ADDENDUM No. 4
January 30, 2025

SUNY ECC NORTH CAMPUS KITTINGER HALL
CLASSROOM INFRASTRUCTURE PHASE 1 IMPROVEMENTS

Ashley McGraw Architects, D.P.C.
125 East Jefferson Street
Syracuse, New York 13202
Phone: (315) 425-1814

**KH
A104**

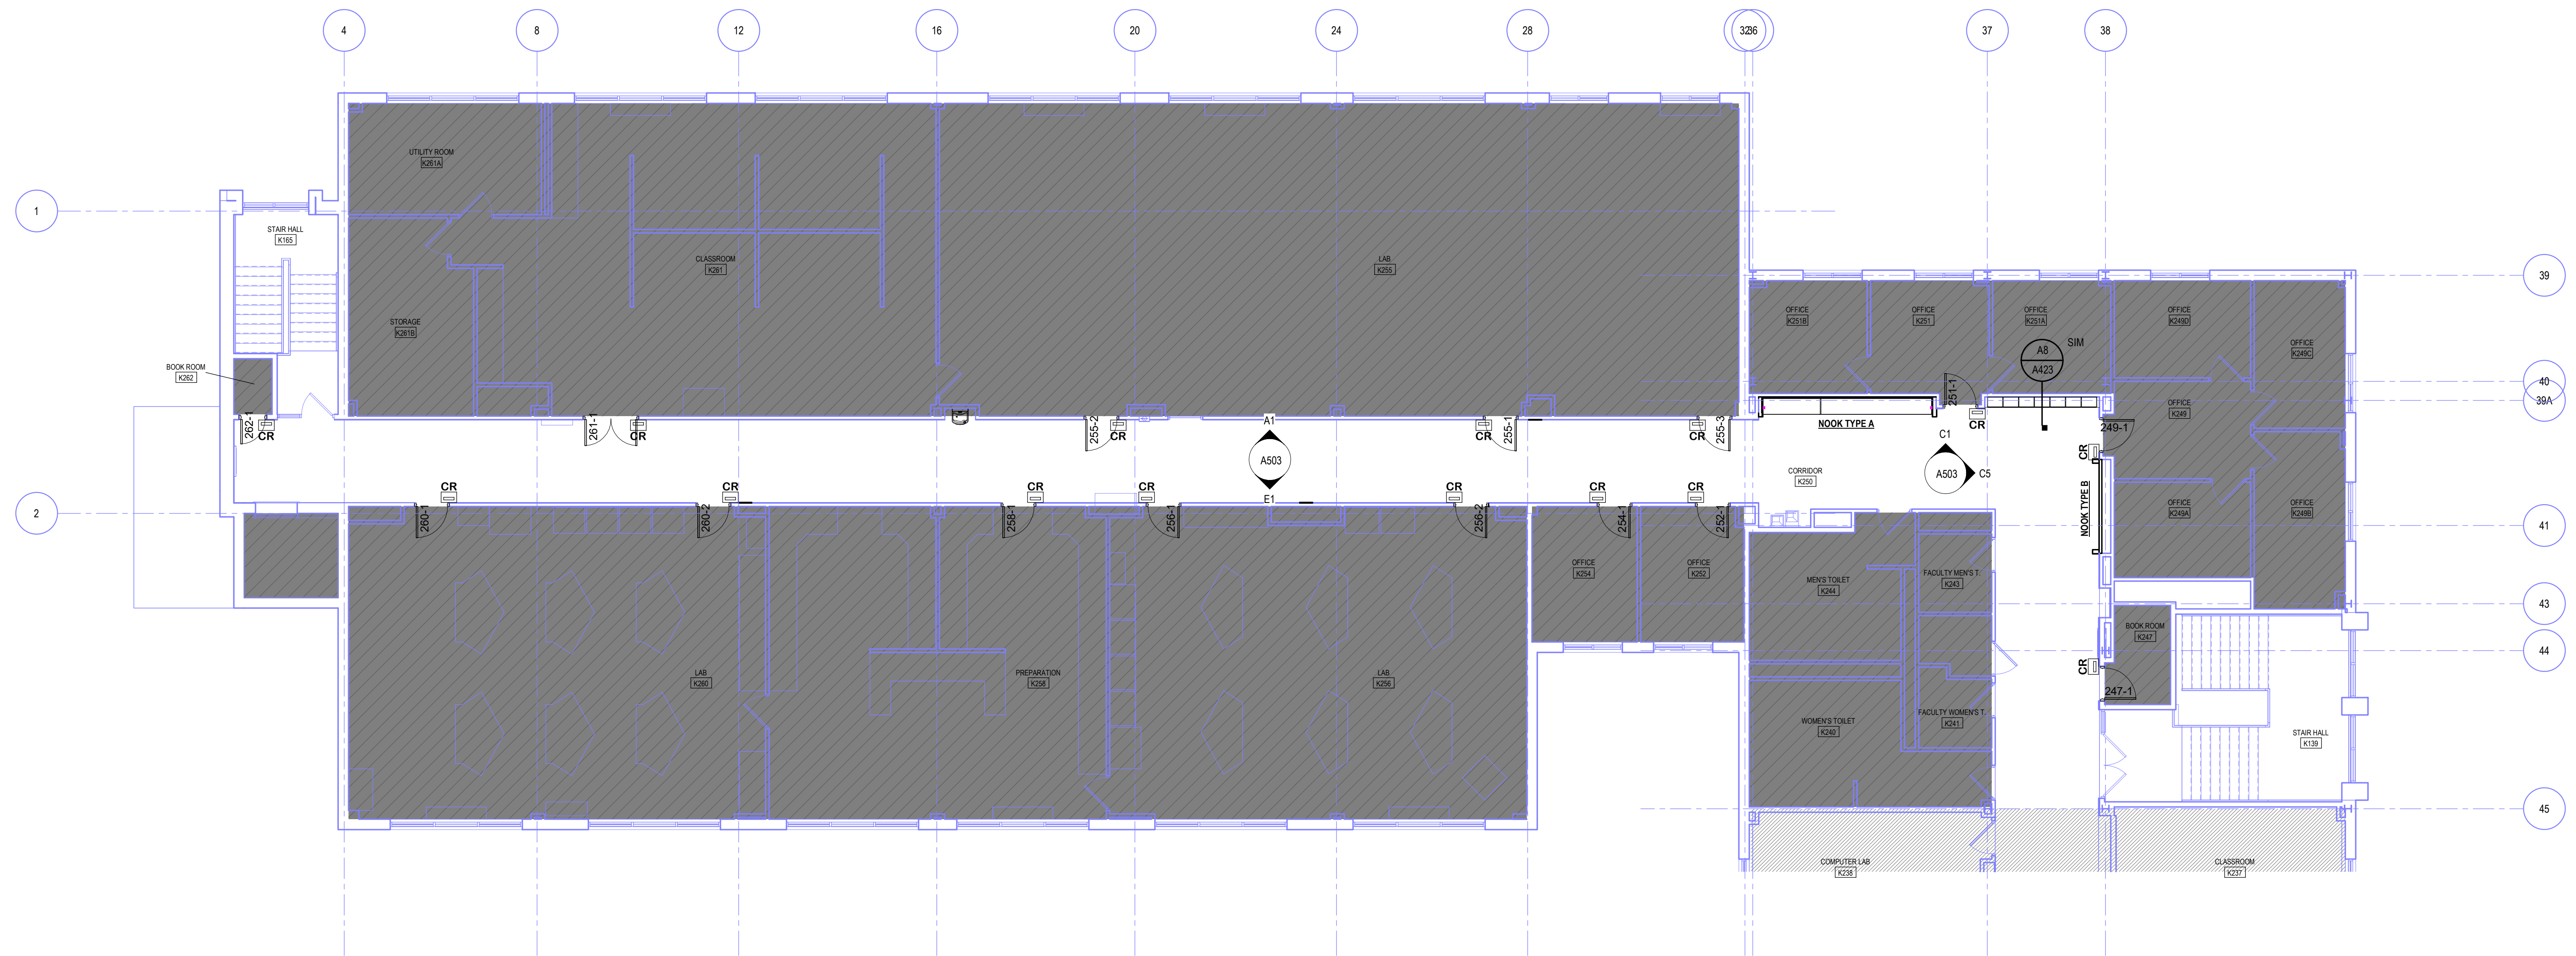
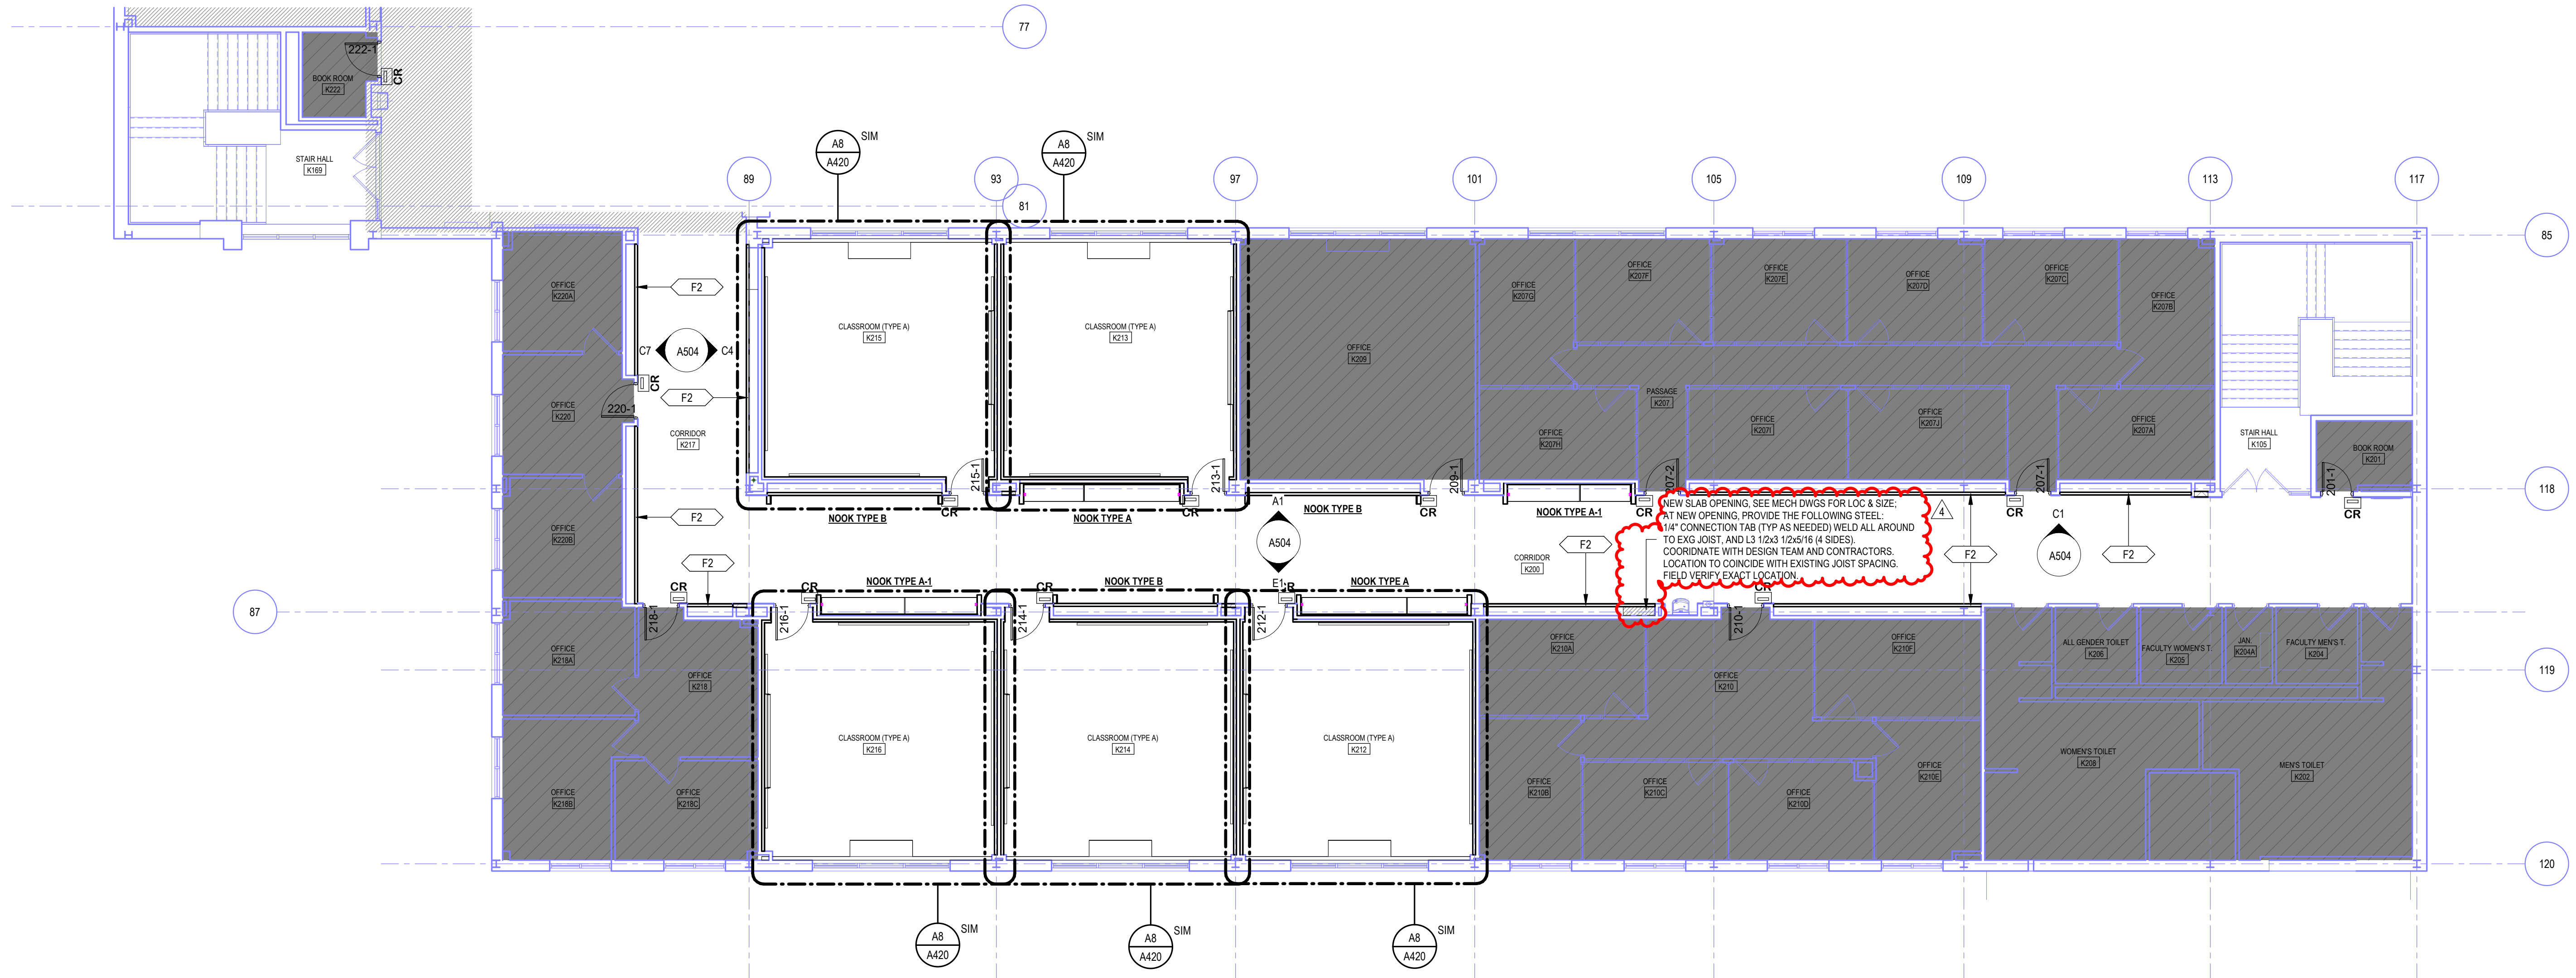
4-D-4 DRAWING A104 – ENLARGED PANS – SECOND FLOOR

1. **REPLACEMENT DRAWINGS one (1) 30" x 42"**
 - A. **REVISE** as per the clouded areas associated with Addendum No. 4.

ENLARGED
REFLECTED
CEILING PLANS -
FIRST FLOOR

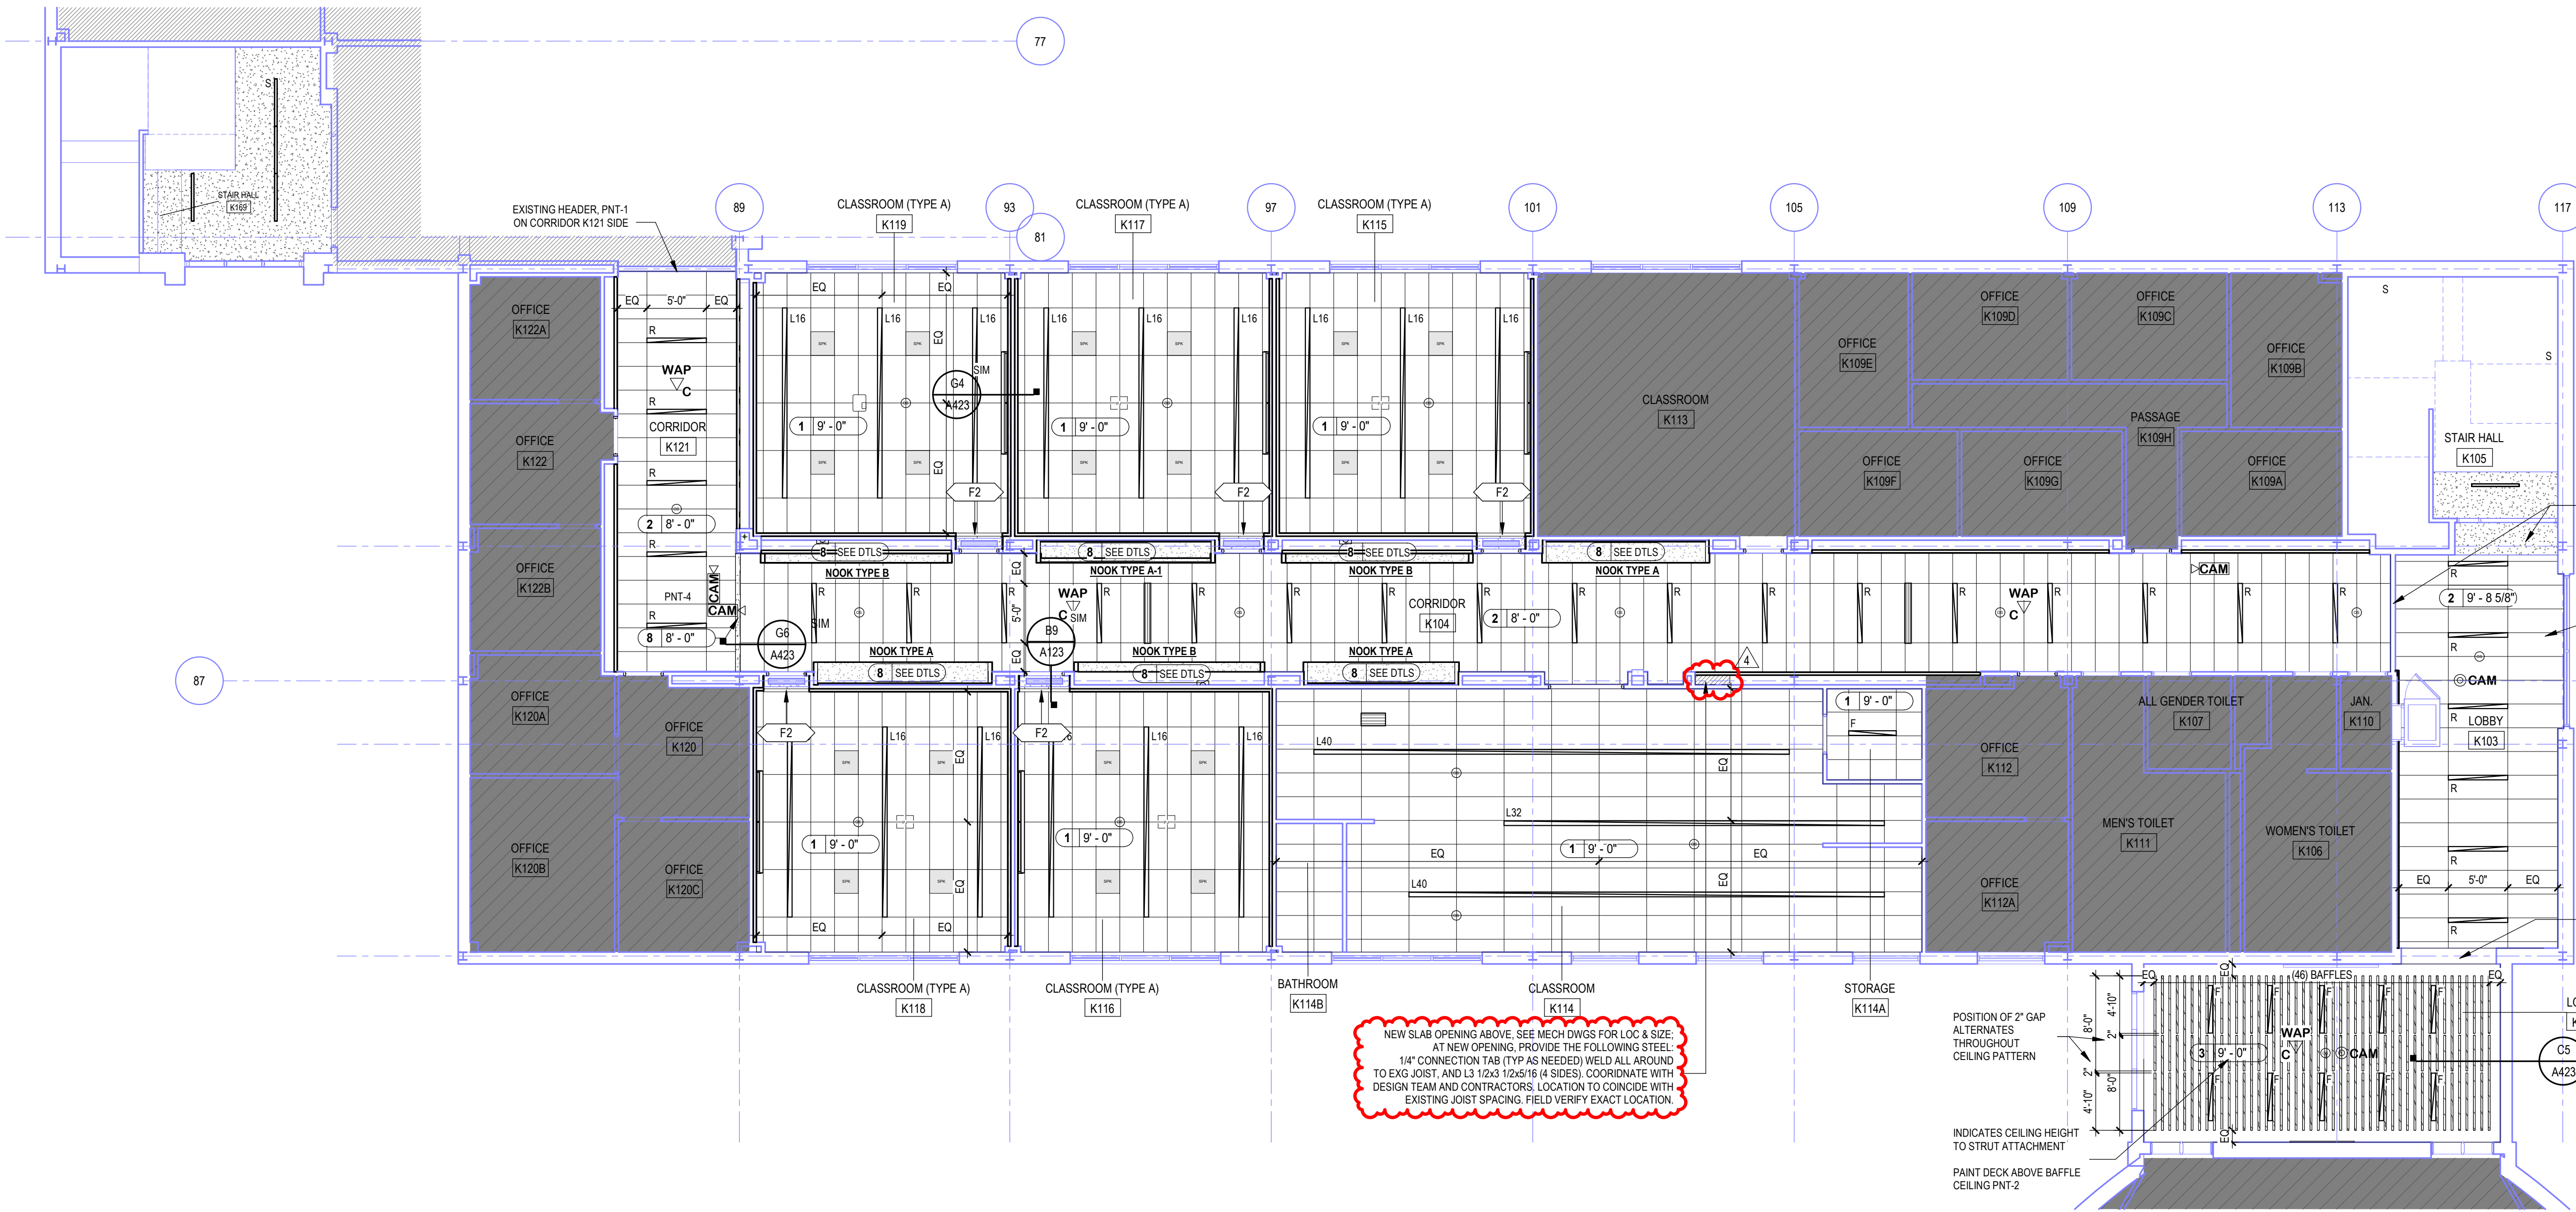
4-D-5 DRAWING A123 – ENLARGED REFLECTED CEILING PLANS – FIRST FLOOR

1. **REPLACEMENT DRAWINGS one (1) 30" x 42"**
 - A. **REVISE** as per the clouded areas associated with Addendum No. 4.

4-D-9 DRAWING A500 – HVAC DETAILS

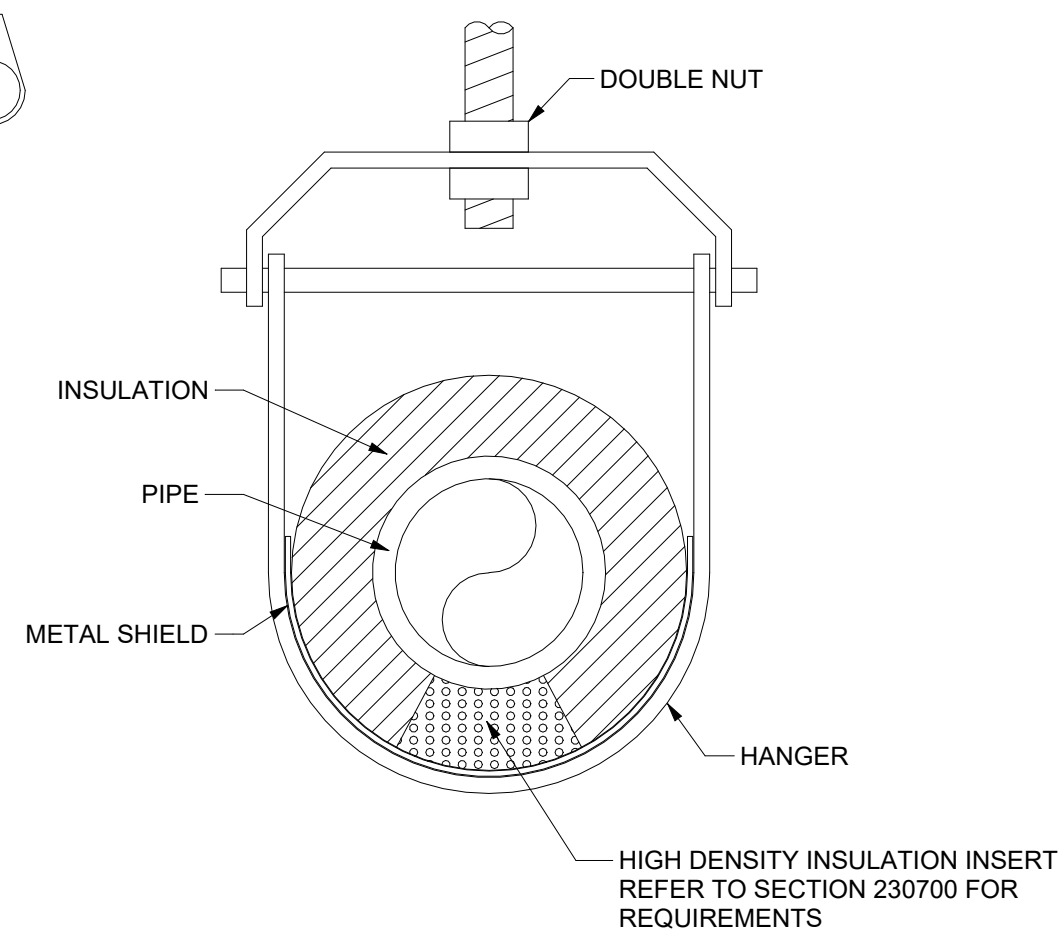
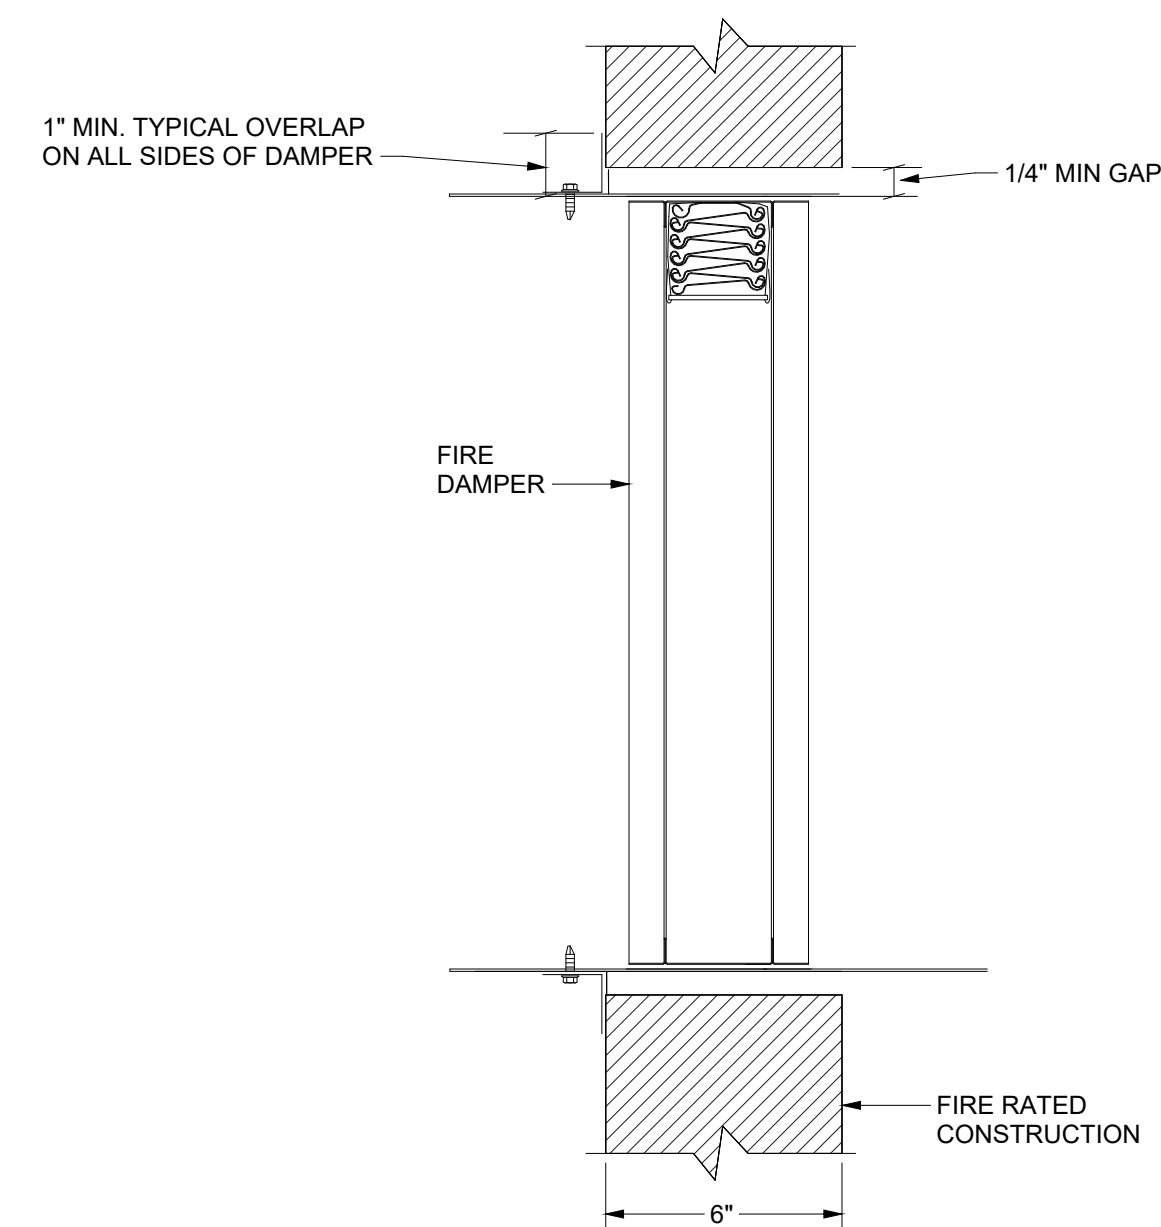
1. **REPLACEMETN DRAWINGS one (1) 30” x 42”**
 - A. **REVISE** as per the clouded areas associated with Addendum No. 4.
REVISE Detail 1, NOTES; 2. and 3.

- NOTES:**
1. REFER TO PLANS & SPECIFICATIONS FOR TYPE OF ENCLOSURE AND FIN-TUBE CHARACTERISTICS.
 2. WHEN FIN RADIATION IS INSTALLED IN CLASSROOMS WITH UNIT VENTS, VALVES SHALL BE LOCATED BEHIND FIN ENCLOSURE AS APPLICABLE. PROVIDE ACCESS DOORS TO SERVICE VALVES, CIRCUIT SETTERS, ETC. DOOR FINISH TO MATCH FIN COVER.
